Assessment of Pacific Gas & Electric Company's Pipeline Safety Enhancement Plan

**Prepared For
Consumer Protection & Safety Division**

December 23, 2011

Figure 5 - PG&E Program Management Organization Structure

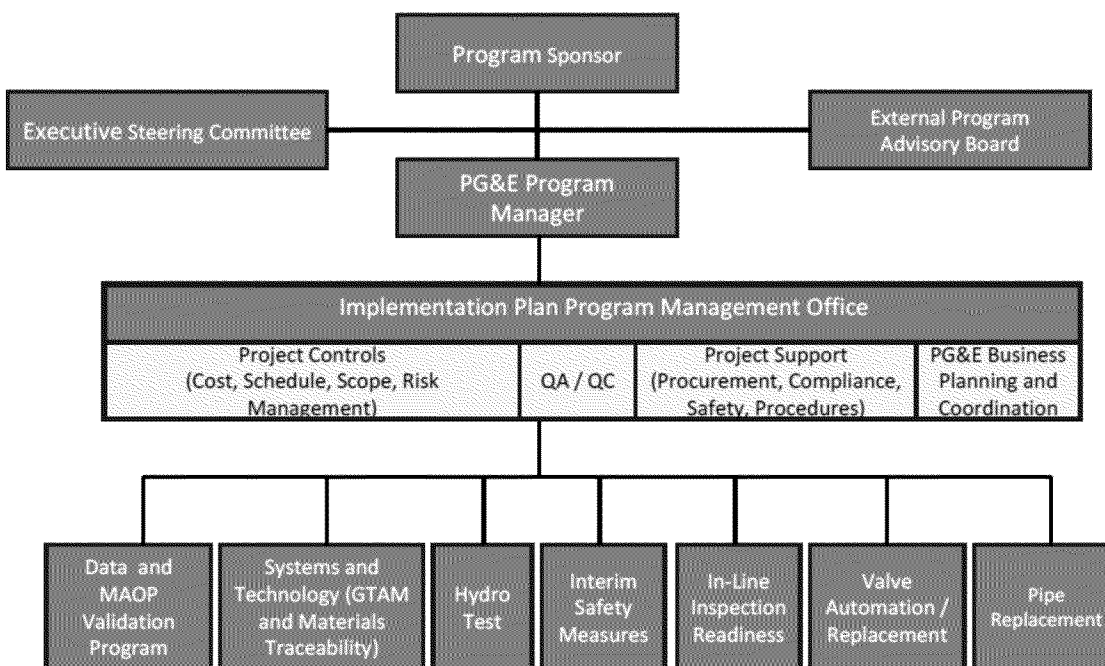
While the specific structure of a program management organization can somewhat vary based on a given program's size, complexity, and client needs, the PG&E program management organization structure, as shown in Figure 2, is consistent with industry practices, as are the roles and responsibilities of the major functions. The major functions of PG&E's programs management organization are:

- The Implementation Plan PMO organizational structure looks to provide a good framework. The organization and governance is based on current industry practices.
